FIELD CHANGE ORDER

Number: HSC50-I009

Applicability: The L0118 Rev B\* module should be installed on all CI750, CI780, CIBCI, & HSCxx nodes used in VAXclusters of 6 (six) or more CI/HSC nodes connected to a common SC008 Star Coupler. L0118s should replace all L0100 Rev D\* link modules; L0100 Rev E\* can coexist with L0118s except in greater than 16 node environment.

FCO HSC50-I009

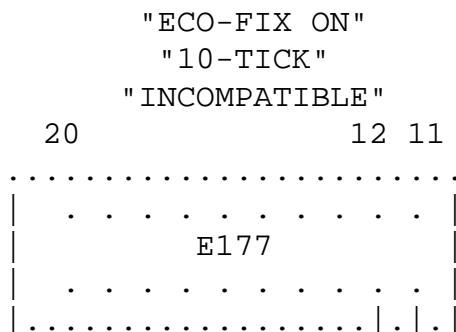
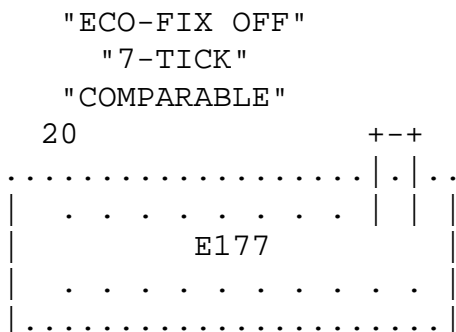
\*\*\*\*\*  
 \* NOTE: REFER TO L0118 FIGURES ON FCO PAGES 13 \*  
 \* AND 14 FOR SW3 AND JUMPERS W1-W4 LOCATIONS. \*  
 \*\*\*\*\*

- o 7/10-TICK COMPAT. MODE SET BY DIP-SWITCH SW3-4 LOCATED AT TOP CENTER OF L0118 TO LEFT (BELOW IF VERTICAL) OF 2 CI-NODE-ADDRESS 8-SWITCH PACKS.
  - "7- TICK COMPAT.,ECO OFF": SW3-4 SWITCH "OFF".
  - "10-TICK INCOMPAT.,ECO ON" : SW3-4 SWITCH "ON" .
  - SWITCHES SW3-2 AND SW3-3 MUST BE "OFF" (AFFECTS DELTA-TIME/QUIET-SLOT).
- o CLUSTER-SIZE FOR 16/32-NODE ADDRESSING AND ARBITRATION IS CONTROLLED BY SWITCH SW3-1. DEFAULT = 16-NODE-MODE = "OFF".
  - 16-NODE MODE (DEFAULT WITH NO CISCE): SW3-1 "OFF".
  - 32-NODE MODE (CISCE 24-NODE CLUSTER): SW3-1 "ON" .
- o L0118 FUNCTION-MODE JUMPERS W1-W4 DEFAULT SETTINGS CHECK:
  - View module with HANDLE-UP and FINGERS-DOWN.
  - Refer to L0118 Figures on FCO page 13 and 14.
  - L0118-B1 HAS ECO-WIRES ON E83-3 and E150-1:
    - = W1 located left of E2: plugged on left 2 stake-pins, marked with "box".

- = W3 located between E54 and E75: plugged on horizontal stake-pins, marked with "box".
- = W2 and W4 located as 4 stake pins below E24 and E62: W2 and W4 "OUT".
- L0118-B2 HAS NO ECO-WIRES TO E83-3 AND E150-1:
  - = W1 located left of E2: W1 on left 2 stake-pins, marked with "box".
  - = W3 located between E54 and E75: W3 on horizontal stake-pins, marked with "box".
  - = W2 located below junction of E24 and E62: W2 on left 2 stake-pins marked with "box".
  - = W4 located below E24: W4 plugged on left 2 stake-pins marked with "box".
